To: T10 Technical Committee  
From: Rob Elliott, HP (elliott@hp.com)  
Date: 29 March 2006  
Subject: 06-166r1 SAS-2 Restrict access to SMP ZONED BROADCAST function

Figure 1 — ZONED BROADCAST from a rogue initiator port

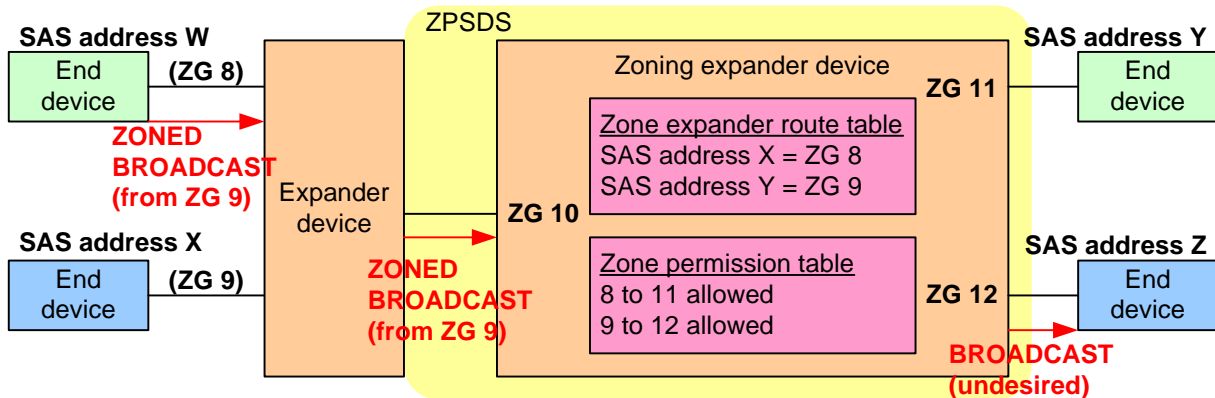
In sas2r03, the function can be sent by any SMP initiator port that has access to the expander device. This means an SMP initiator port in one zone group can introduce BROADCAST traffic into other zone groups (see figure 1), which somewhat defeats the purpose of zoning.

Access needs to be restricted so SMP initiator ports cannot sneak traffic into other zone groups unless they have permission.

Figure 2 — BROADCAST escaping zone

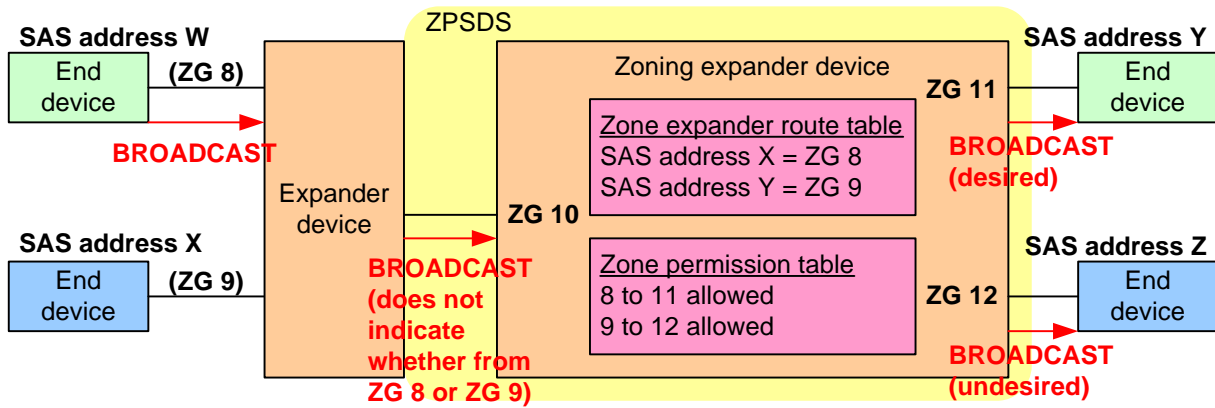
With the “zone address resolved” mode, an expander phy on the boundary of the ZPSDS that is attached to another expander device may be the entry point for traffic from devices in more than one zone group. However, since BROADCAST primitives do not carry source zone group information, an incoming BROADCAST primitive must be considered to have come from any of those zone groups. The expander device must treat it as coming from all the possible source zone groups and forward it to all destination zone

groups to which all the source zone groups on that expander phy have permission (see figure 2). This is undesirable.

A mechanism should be defined to allow the expander device outside the ZPSDS to identify the source zone group of the BROADCAST so it can be forwarded only to the proper destination zone groups. This cannot be perfect (since the expander device is not trusted), but it can limit the extent of the BROADCASTs if it is behaving (and anyway is restricted only to the zone groups that are sharing the door into the ZPSDS).

Figure 3 — BROADCAST kept in zone

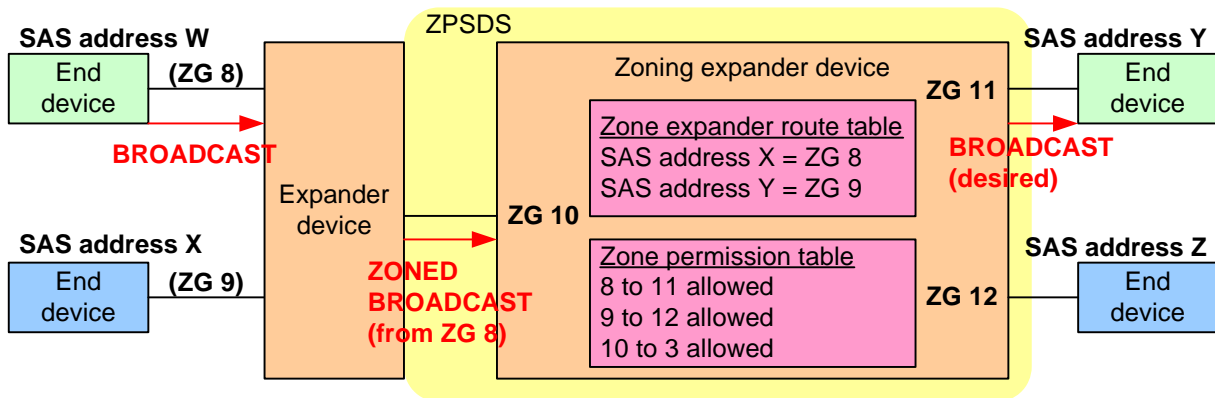
A new zone group 3 is proposed for this purpose. The zone permission table must indicate the SMP initiator port has access to zone group 3 for the SMP ZONED BROADCAST function to be allowed. Zone group 2 is also used for access to ZONED BROADCAST. This allows an external expander device, if its own source zone group has access, to use SMP ZONED BROADCAST (see figure 3).
